**MOUND PLANNING COMMISSION REGULAR MEETING AGENDA
TUESDAY, DECEMBER 2, 2025, 6:00 P.M.
COUNCIL CHAMBERS, MOUND CENTENNIAL BUILDING
5341 MAYWOOD ROAD, MOUND, MN**

PLANNING REPORT

TO: Planning Commission
FROM: Sarah Smith, Community Development Director
Rita Trapp and Mia Colloredo-Mansfeld, Consulting Planners
DATE: November 26, 2025
SUBJECT: North Pointe at Halsted Bay (Planning Case No. 25-12)
Public Hearing – Comprehensive Plan Amendment and Major Subdivision-Preliminary Plat; and review/discussion/consideration of Rezoning and a Conditional Use Permit (CUP) for a Shoreland Planned Unit Development (PUD) and to allow multi-family residential and townhouses in the R-3 district
APPLICANT: Robert Bauman
LOCATION: 6625, 6627, & 6639 Bartlett Blvd and the property with PID 22-117-24-43-0028
(PID Nos. 22-117-24-43-0046, 22-117-24-43-0028, 22-117-24-43-0009, and 22-117-24-43-0007)
MEETING DATE: December 2, 2025
COMPREHENSIVE PLAN: Low Density Residential and Medium Density Residential
ZONING: R-1, R-3 PUD, Shoreland Overlay District

TREE PRESERVATION PLAN

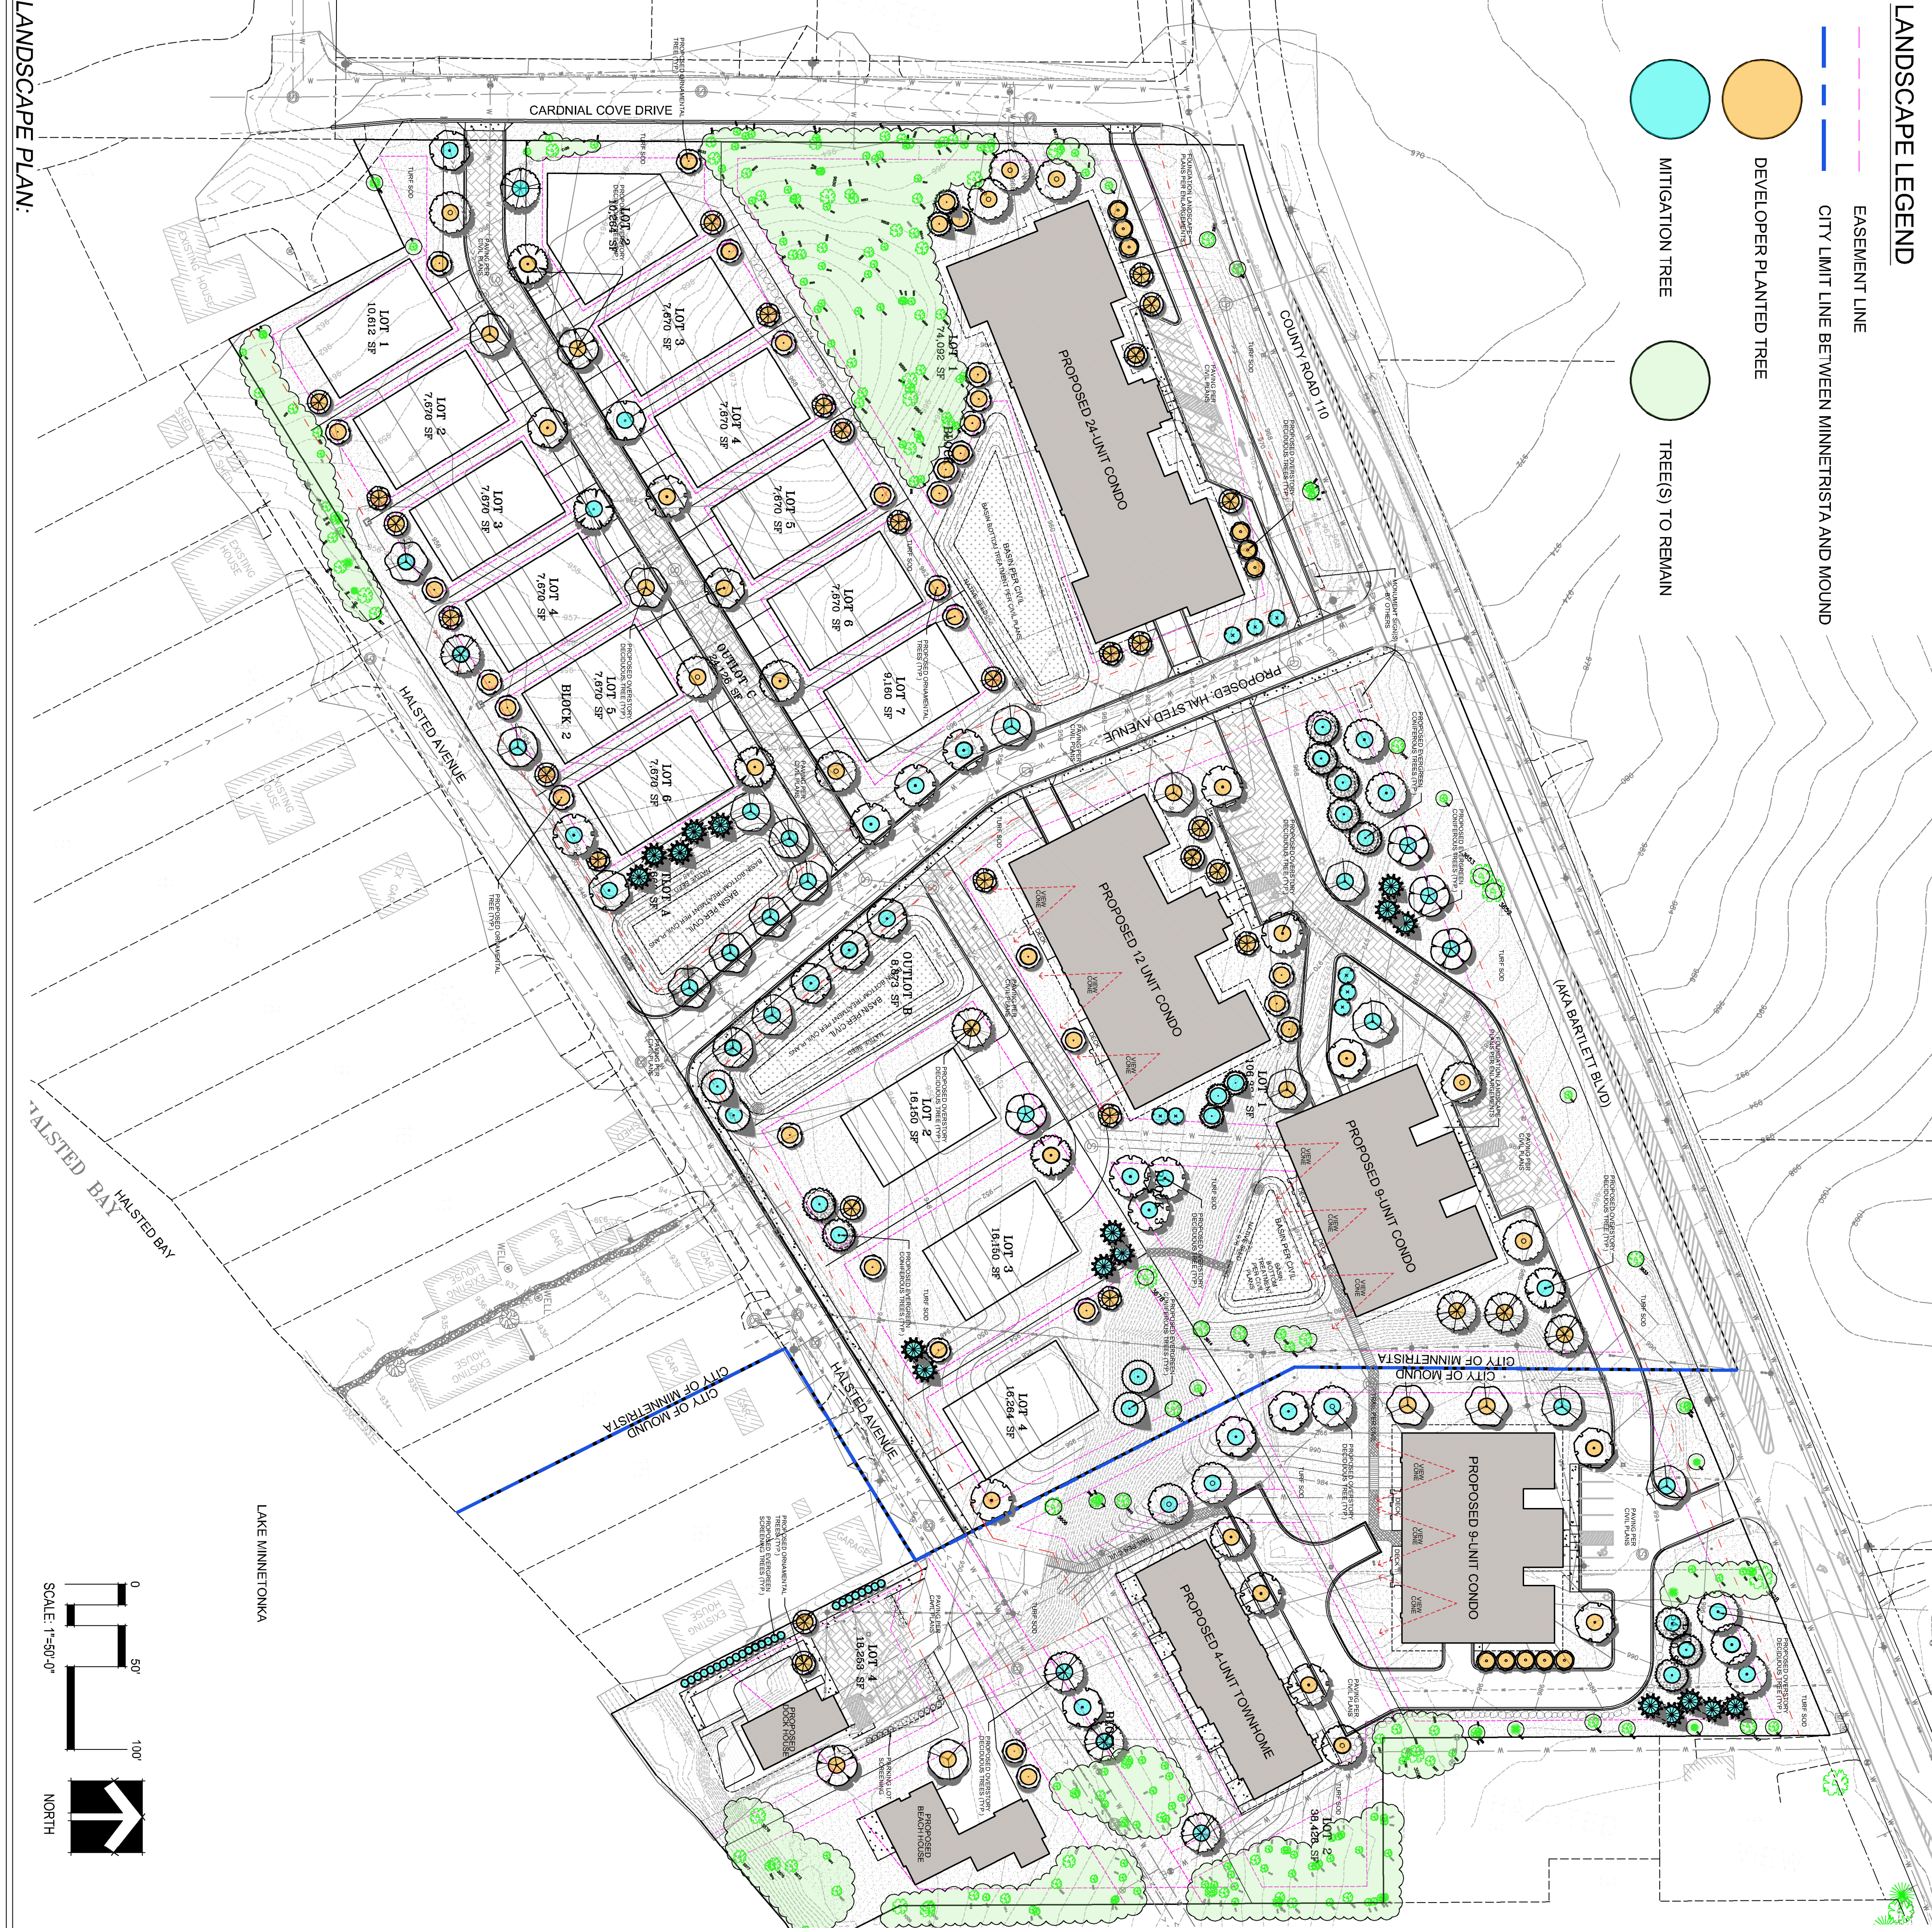
- Some trees proposed to be removed are hidden beneath the proposed building footprints. There should be an export of the tree preservation plan that clearly shows all trees proposed for removal.

- Some trees which are identified for removal appear that they could possibly be preserved. For example, trees south of the SW corner of the 4-unit townhouse structure. A clearer grading plan with existing and proposed contours labeled is needed to confirm.

- The numbers for the existing trees are blurry and too small to read in places. The plans should be re-exported with clear numbers and a key provided that identifies what the species and size of each tree is. In addition, without a key that shows species and caliper inches of each tree, it cannot be determined whether or not the trees they are intending to preserve have enough of their critical root zone protected from grading impacts.

- Some of the tree protection fencing shown overlaps the proposed grading, such as at the boulder retaining wall east of the condominium building. No grading should be conducted within critical root zones of trees to be preserved. If the applicant is installing a retaining wall within the root zones, these trees may not survive. Clarity is needed before the tree preservation plan can be accepted.

1 9 UNIT CONDO FOUNDATION PLANTING PLAN

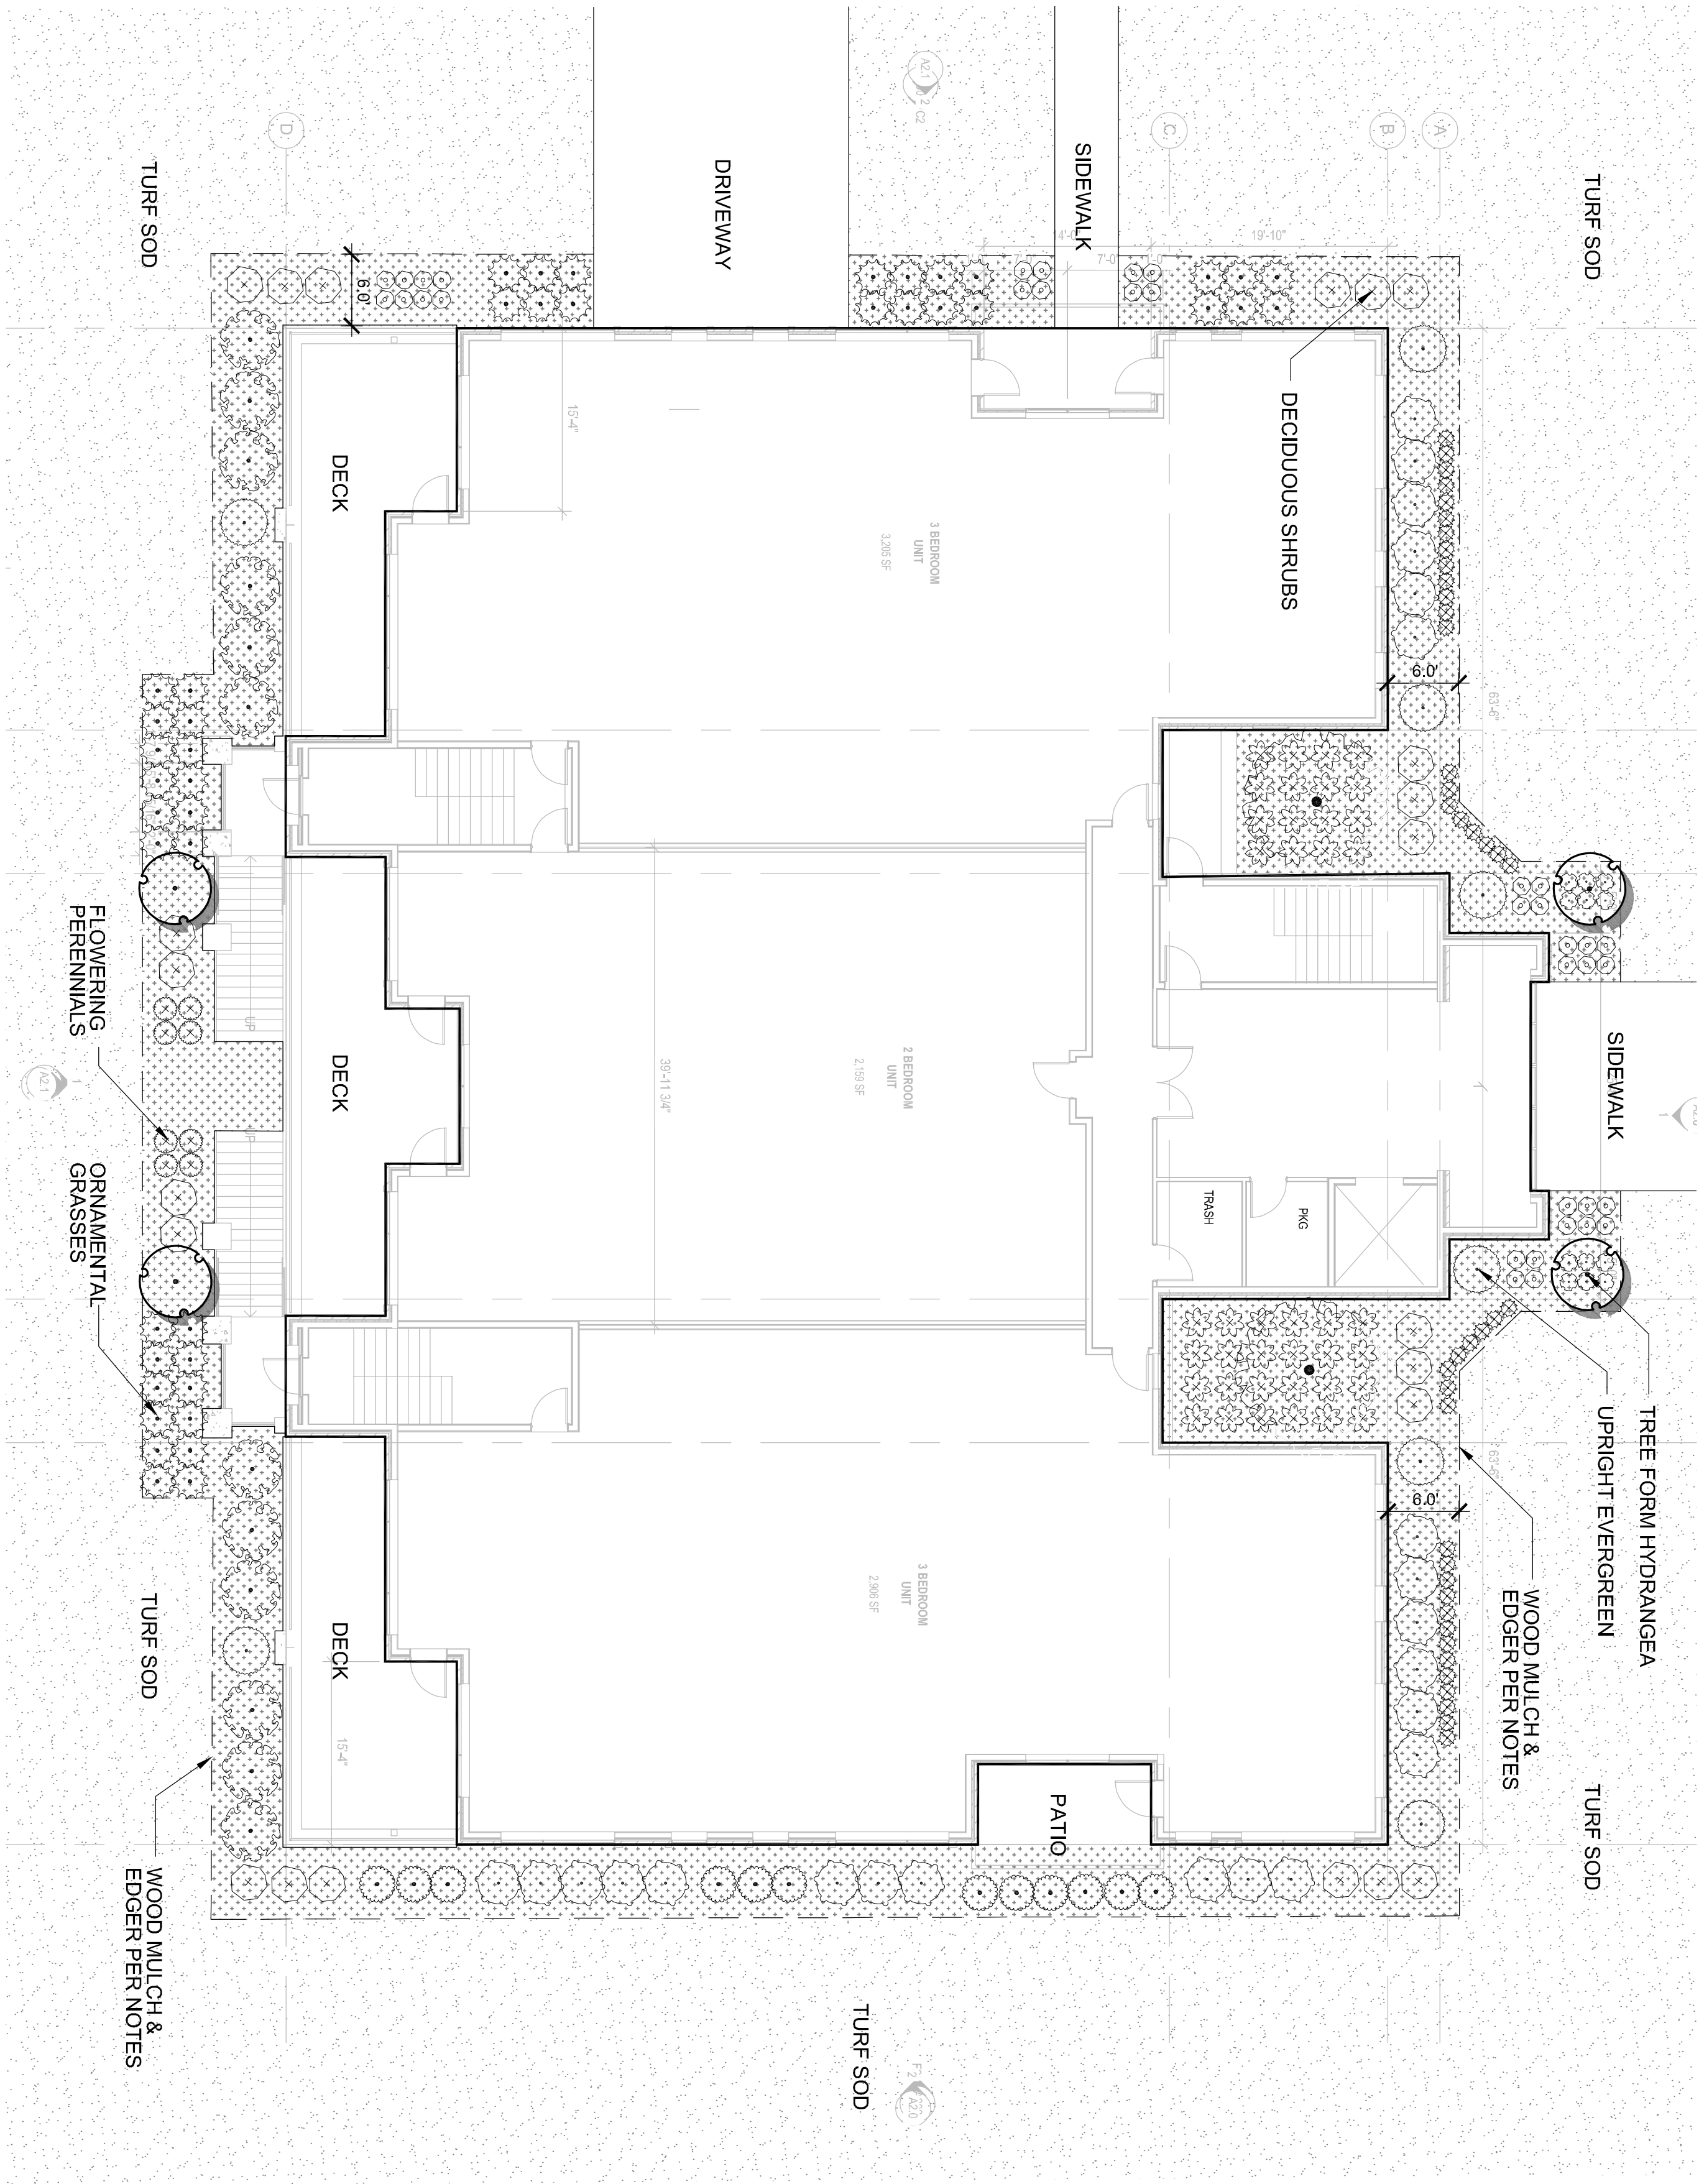
- The landscape plan shall be revised to use a native ornamental grass cultivar in place of the *Miscanthus sinensis* 'Purpureus' Flame Grass. Flame Grass can be aggressive/invasive and is not advised to be used this close to a lake.
- Clarification should be provided about whose responsibility it will be to install the trees on the single-family lot.
